Landscape Mitigation Plan

Contract no. KL/2014/03

Kai Tak Development – Stage 3 Infrastructure Works for
Developments at the Southern Part of the Former Runway

Contract No. KL/2014/03 - Kai Tak Development - Stage 3 Infrastructure Works for
Developments at the Southern Part of the Former Runway
Submission of Landscape Mitigation Plan

Figure A3- Tree Planting Plan

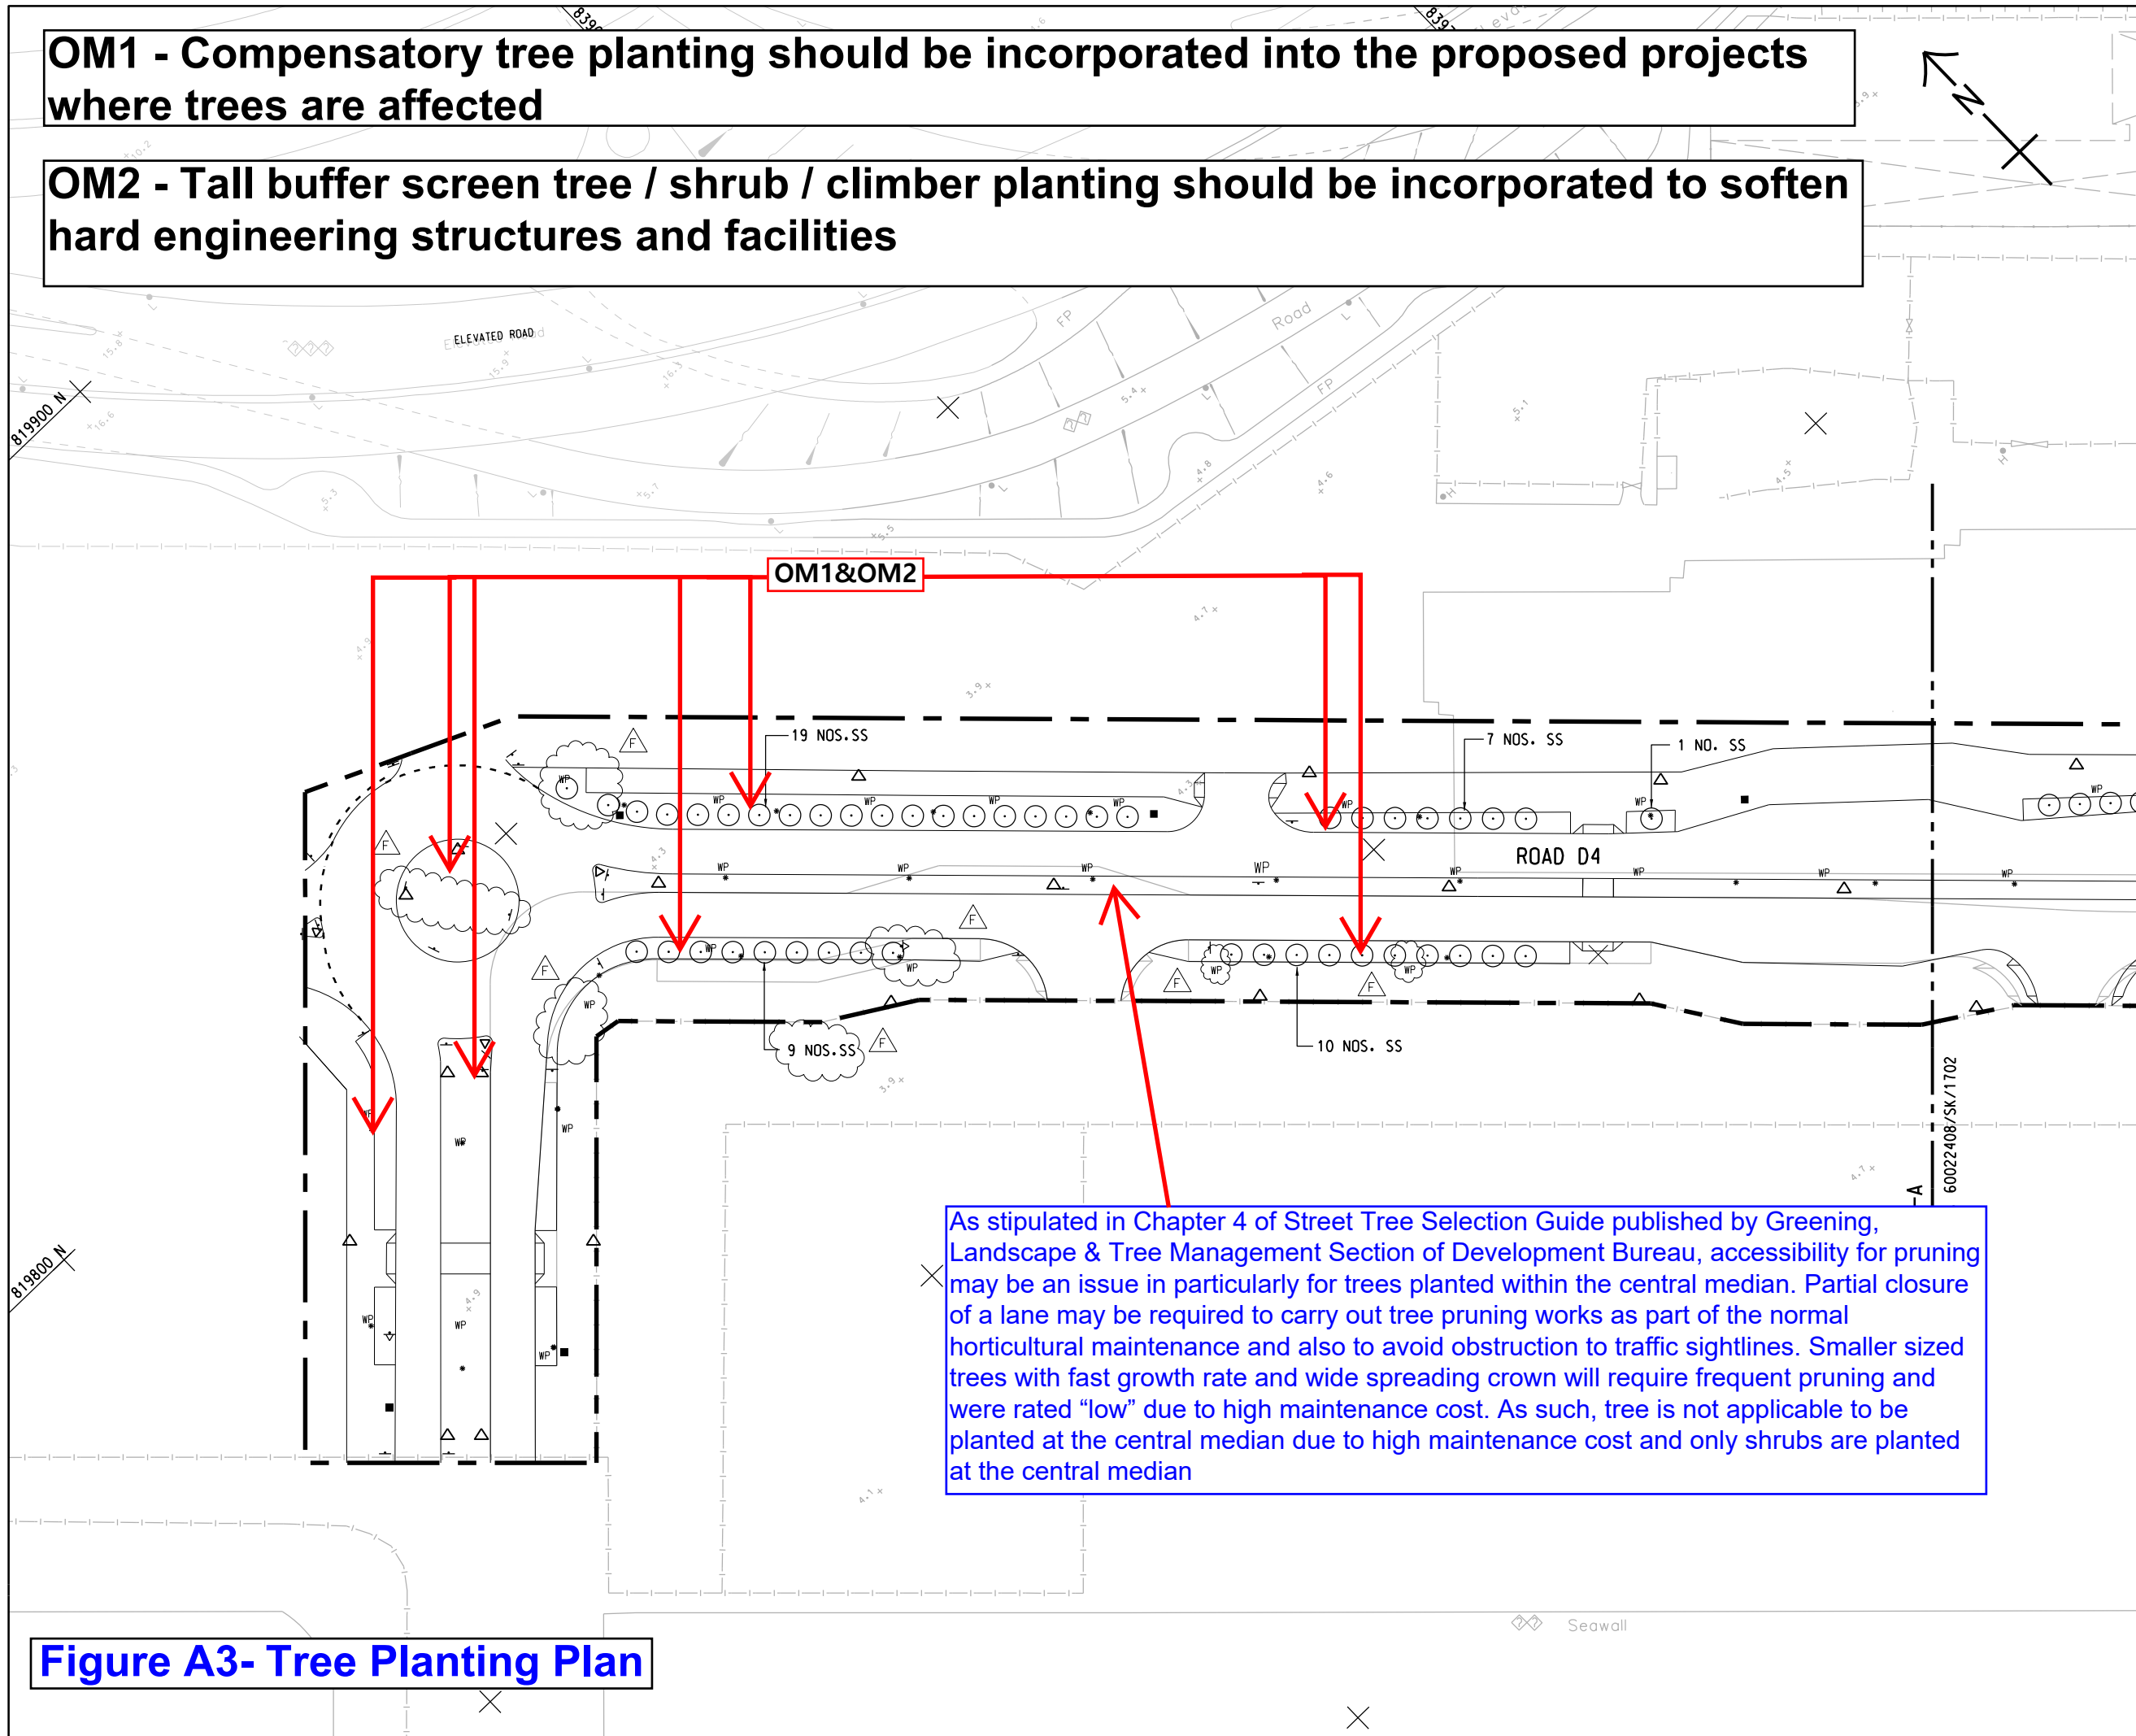
9.	When compared with Fig. 13.6.3 of AEIAR-130/2009, tree and shrub planting in the central median is not observed. Justification for possible design change and alternative landscape treatment, where appropriate, should be presented in the submission. Besides, the updated no. of new tree planting should be clearly indicated in the submission.	Please be clarified that shrub would be provided in the central median at Road D4. Due to the space limitation of central median at Shing Cheong Road, Cheung Yip Street and Kai Tak Bridge Road, no tree would be provided in the central median of the concerned area. For the latest tree planting plan of Shing Cheong Road, Cheung Yip Street and Kai Tak Bridge Road, please find the attached Appendix A - Figure A3 to A5 for your information.

Figure A10- Comparson of Figure 13.6.3 of AEIAR-130/2009

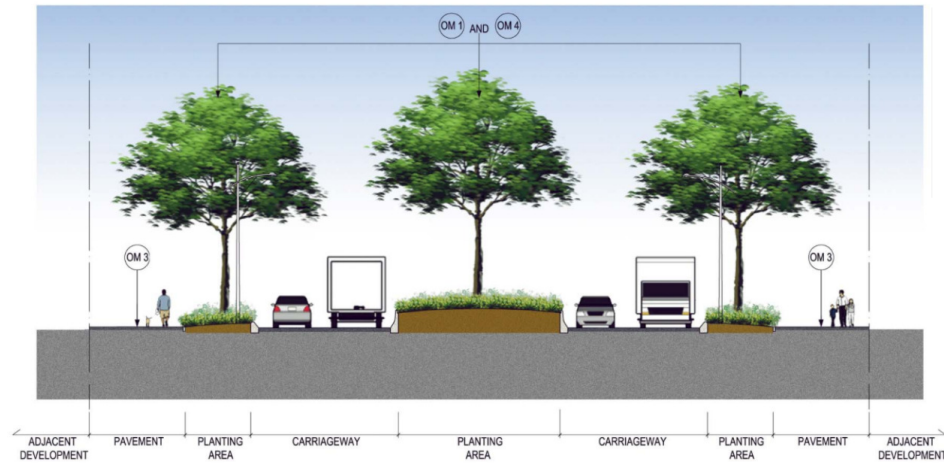
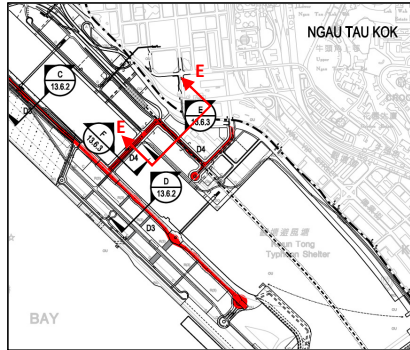
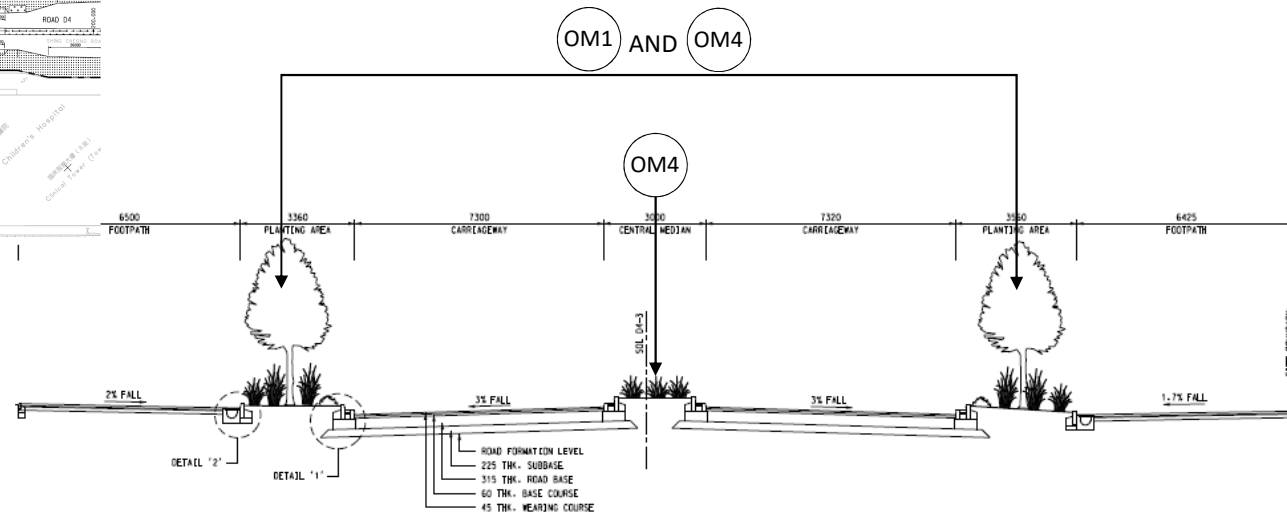
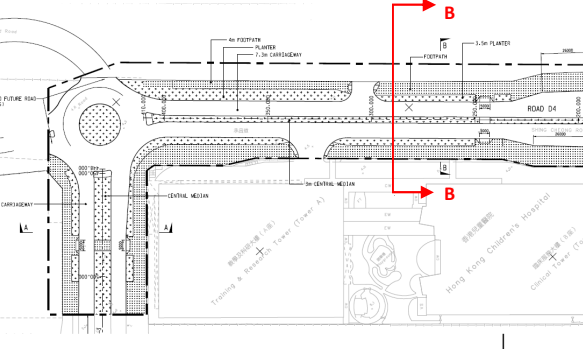
3.	The Permit Holder should arrange the LMPs to relate to / compare with the corresponding AEIARs, i.e. Figure 13.6 and Figure 13.6.2 of AEIAR-130/2009 and Figure 9.11.2 of AEIAR-174/2013, etc.	The comparison with the corresponding AEIARs are shown in Appendix A - Figures A10 and A11.

Figure A12 - Soil Mix and Planting Drainage Details

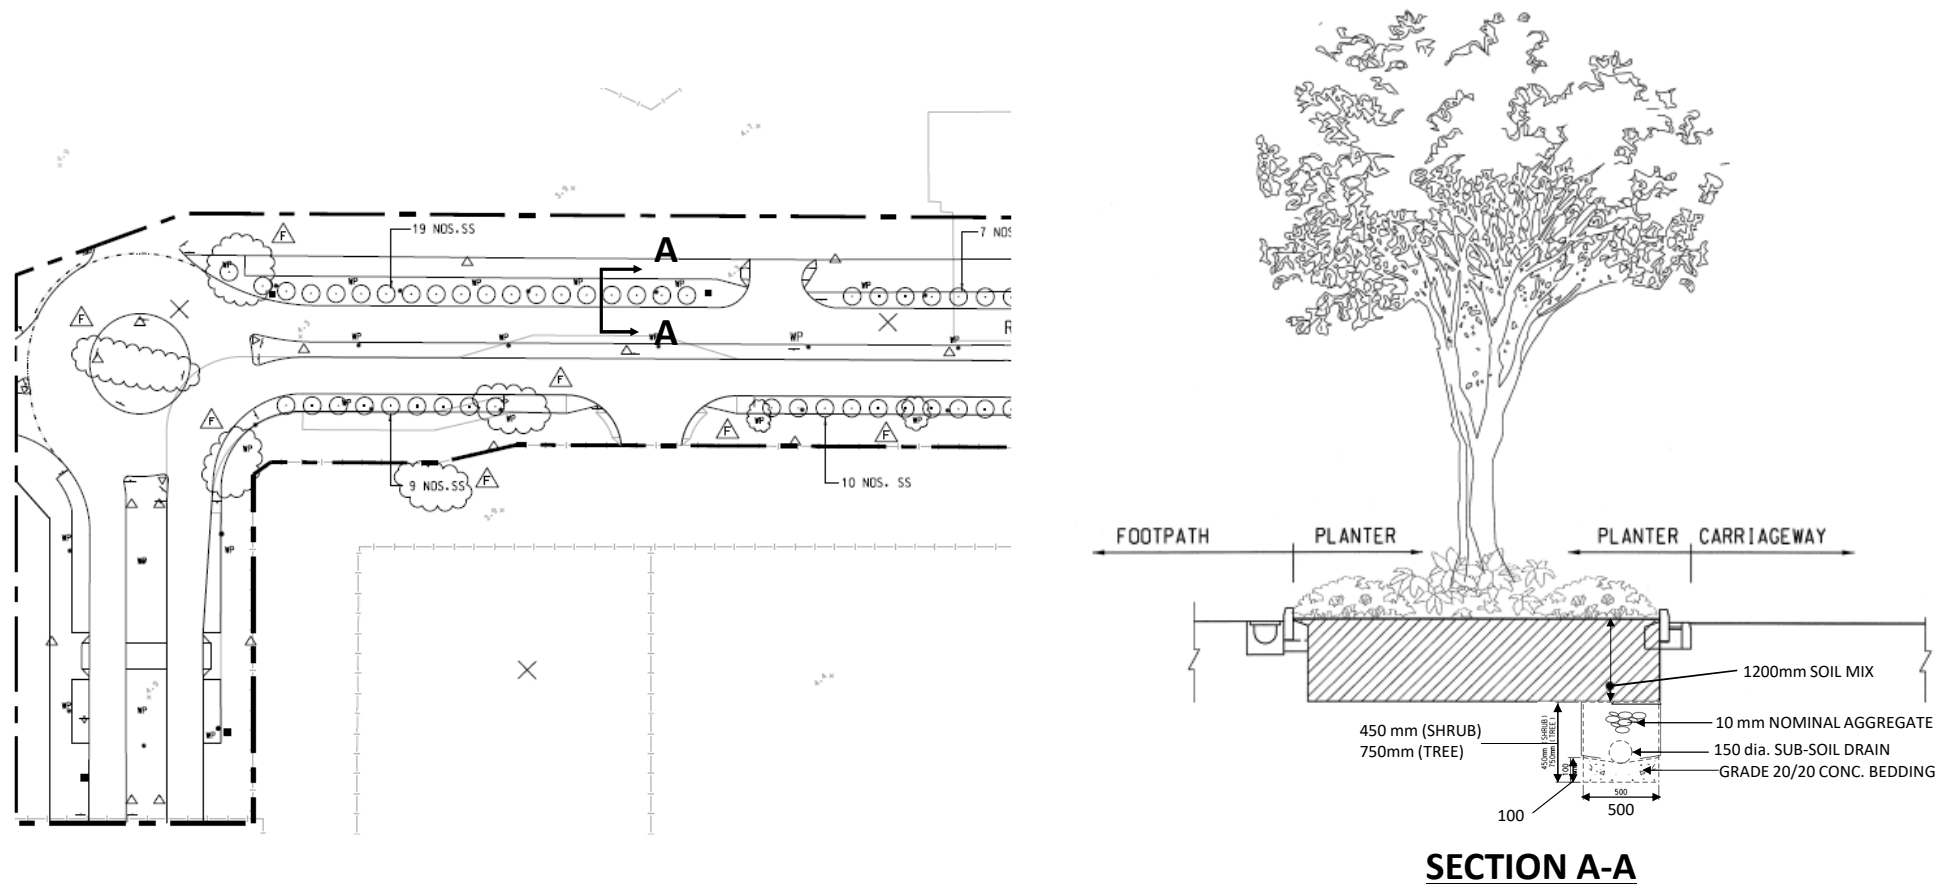
C&R No.	Comments	Responses
10.	Typical details showing the minimum clear soil depth with proper drainage for different types of plantings should also be provided to demonstrate the sustainability of planting.	Please refer to the typical details of minimum clear soil depth and drainage at planter are shown in Appendix A - Figure A12.
	<i>OM5 -Aesthetically pleasing design as regard to the form, material and finishes shall be. incorporated to all buildings. engineering structures and associated infrastructure facilities</i>

Figure B1 - Tree Protection Plan

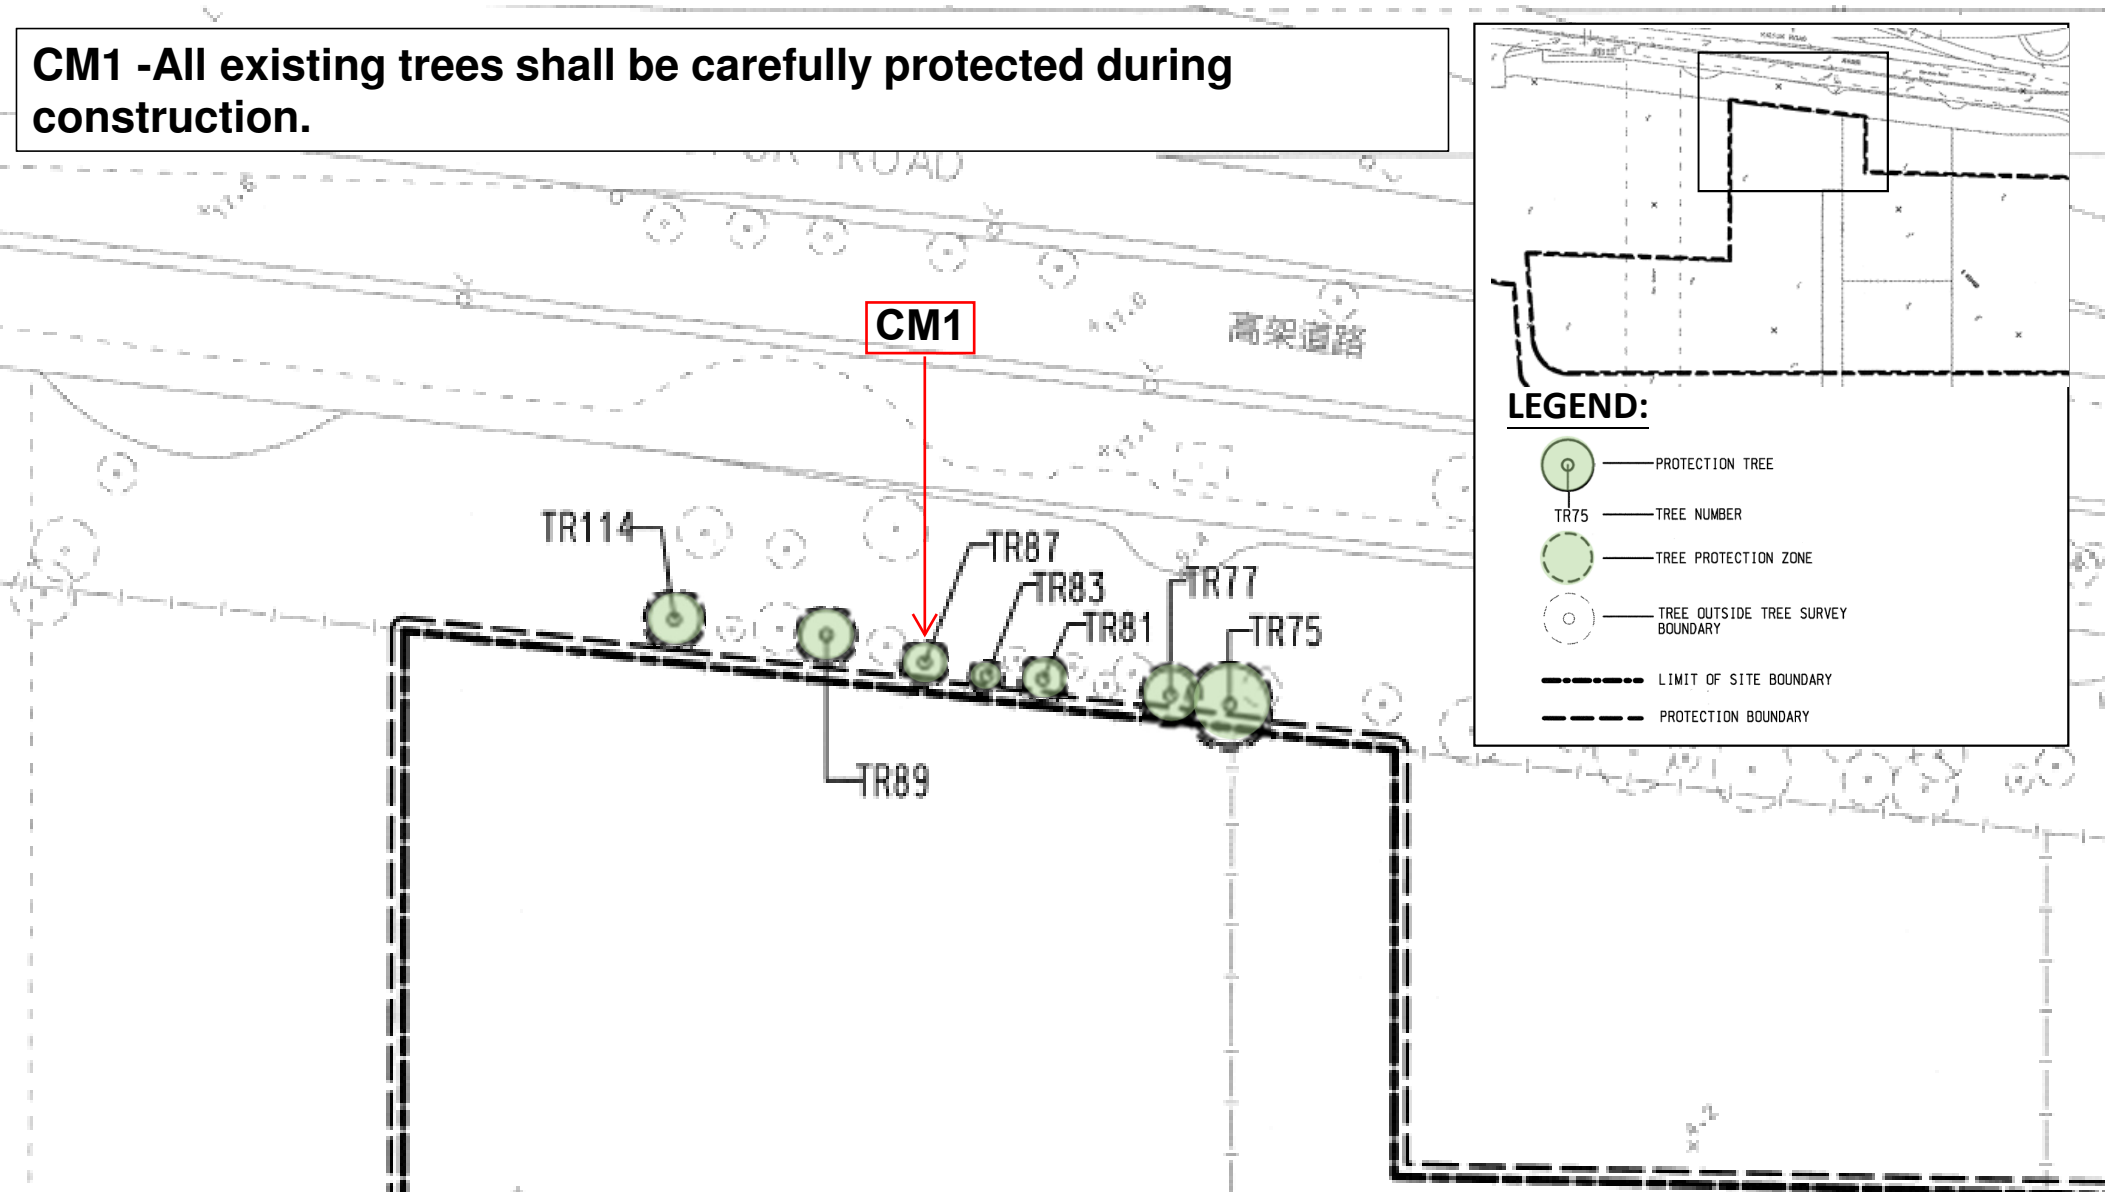
6.	Tree protection plan is missing.	Please find the blow up of tree protection plan as shown in Appendix B Figures B1 to B2.
